<input type="checkbox"/> Sidewalk Waiver (Form V2)		
<b>SITE PLANS</b>		<input type="checkbox"/> Waiver to IDO (Form V2)	<b>APPEAL</b>
<input checked="" type="checkbox"/> DRB Site Plan (Form P2)	<input type="checkbox"/> Waiver to DPM (Form V2)	<input type="checkbox"/> Decision of DRB (Form A)	
<b>BRIEF DESCRIPTION OF REQUEST</b>			
Apartment complex development

**RE: Sonata Unit 4 Trails Apartments  
Tracts 1, 2, and 3, The Trails Unit 4  
Second DRB Submittal**

PROJECT NAME: SONATA TRAILS UNIT 4 APARTMENTS

**SHEET NUMBER:** C-108

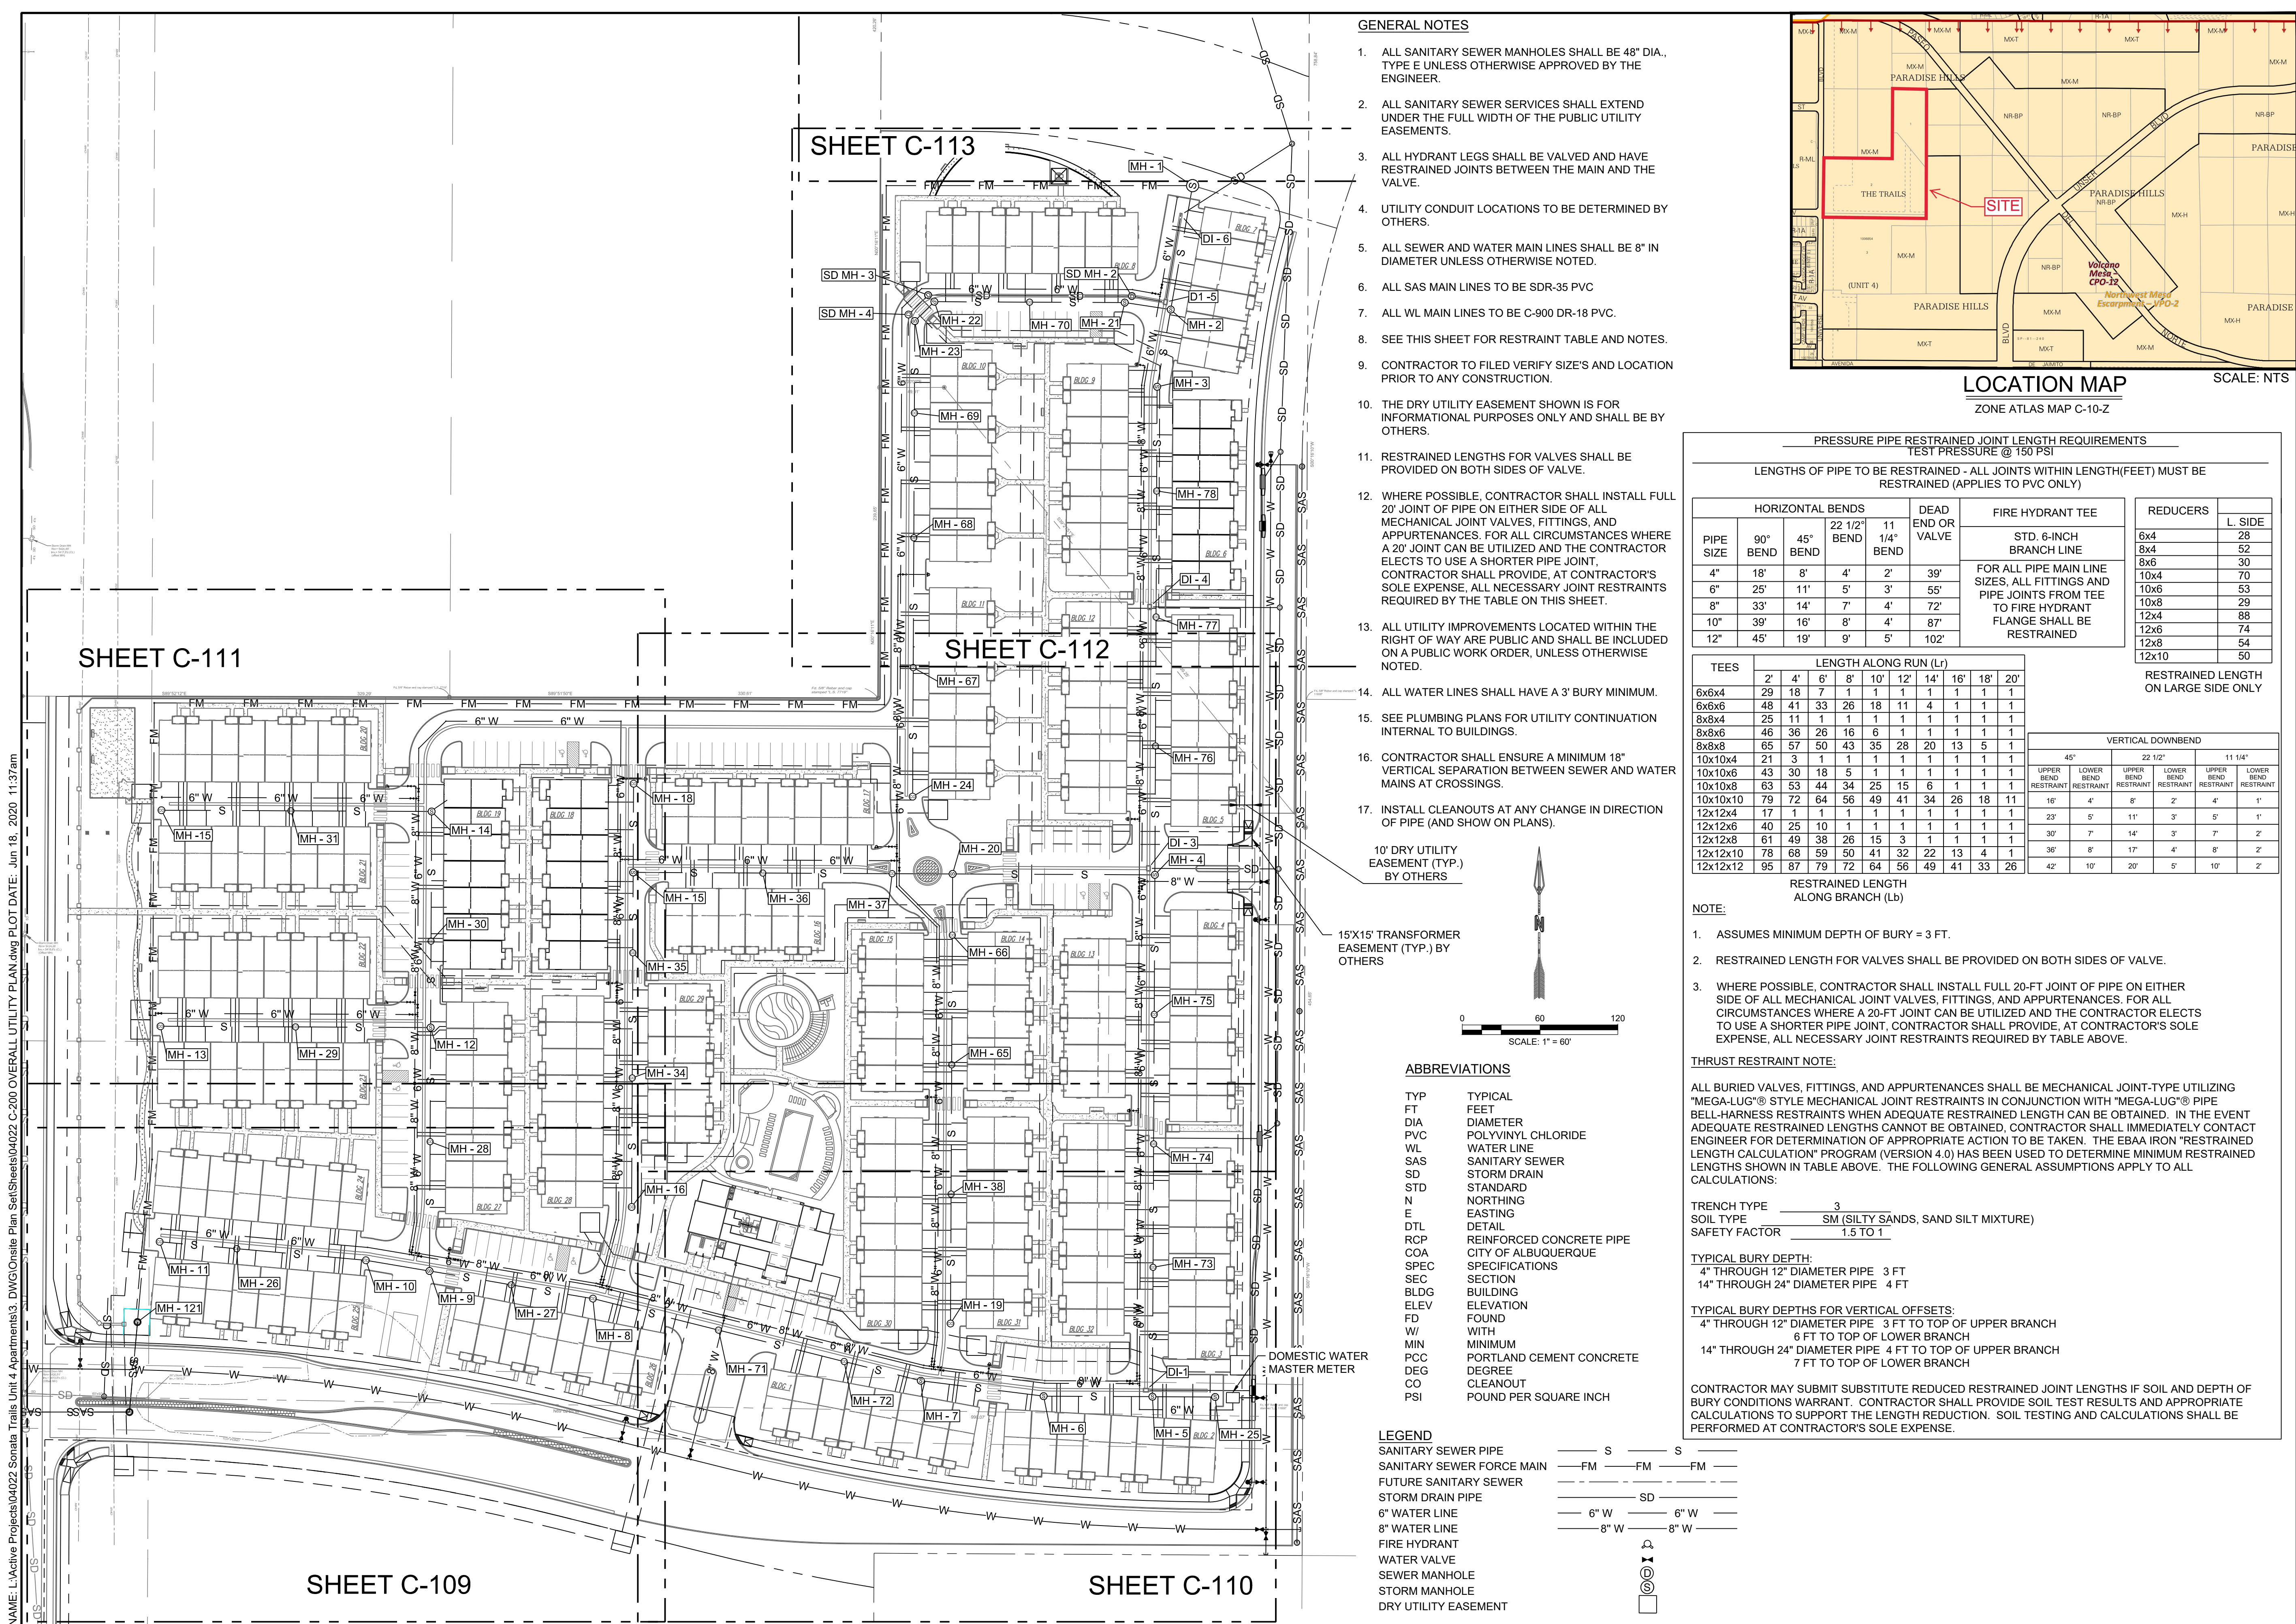
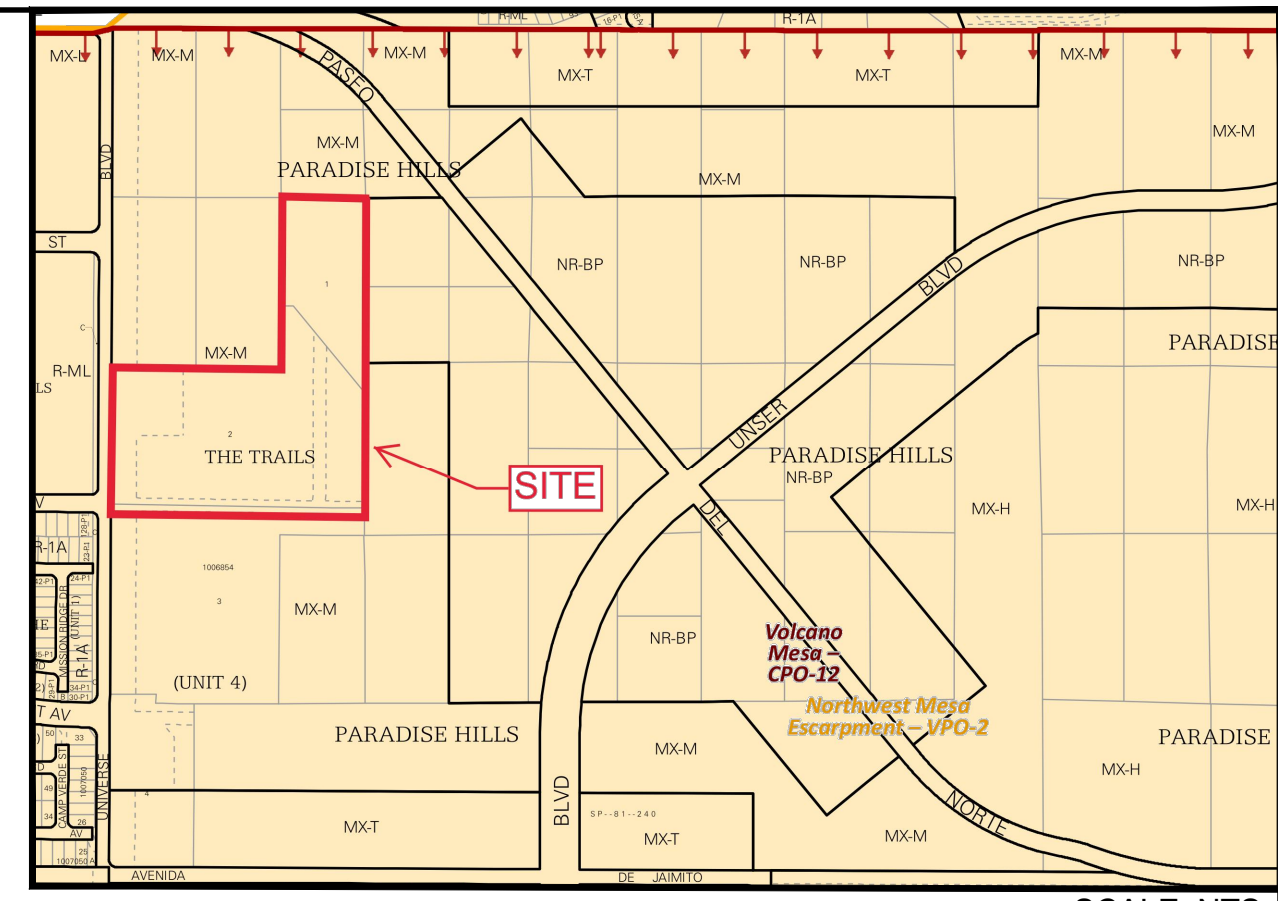
3. Utility Plan
    - a. A meter is shown for each unit. This is not consistent with a previous proposal for a previous request for availability statement which included master meters for the entire development. The proposal for individual meters for each unit (which is not consistent with the calculation for UECs in the Rate Ordinance) appears to be significantly more costly.

- e. Public waterline and sanitary sewer along the frontages of Treeline Ave. and Chatsworth Dr. are not shown to be proposed on the Utility Plan.
- / Public waterline and sewer are shown in Chatsworth Dr. and public waterline is shown in Tree Line Ave. See revised utility sheets.

- / The meters for each unit have been removed. We are proposing a master meter at the southeast corner of the development. See revised utility sheets.**

- / All utilities on-site will be private and all utilities within the right-of way will be public. See revised note 13 on sheet C-108.

TREE LINE / CHATSWORTH / OAK RIDGE TYPICAL SECTION  
NTS

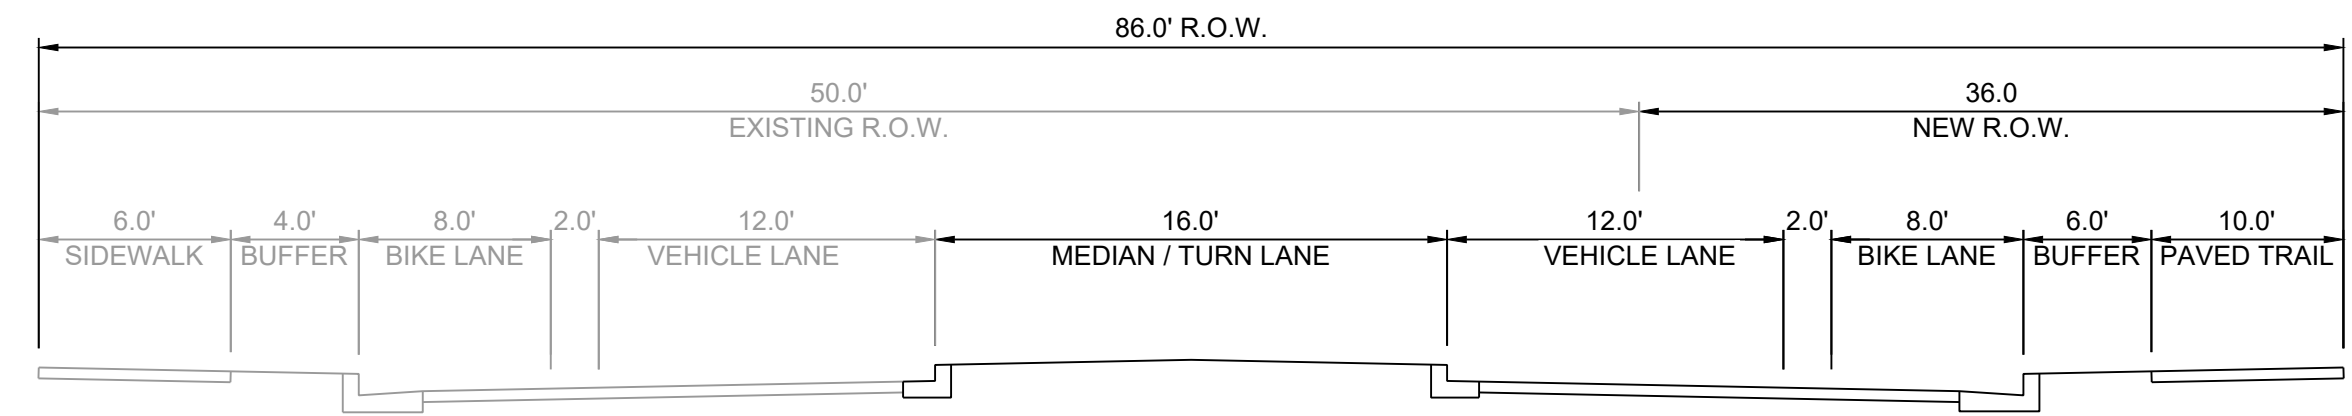
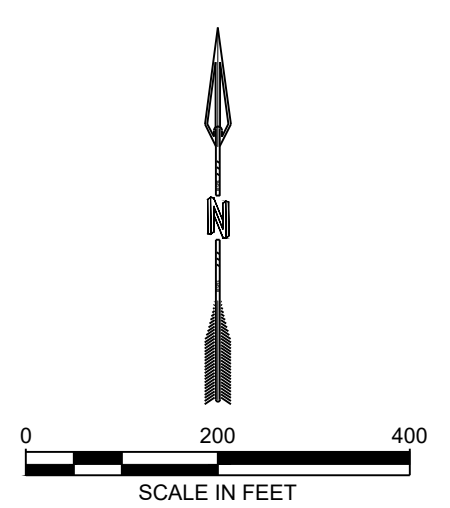
11. Note DMD's comments on cross-section improvements.  
/ 1-foot has been added to the parking spaces along Tree Line and Chatsworth and 1-foot has been subtracted from the buffer area. See revised cross-sections.
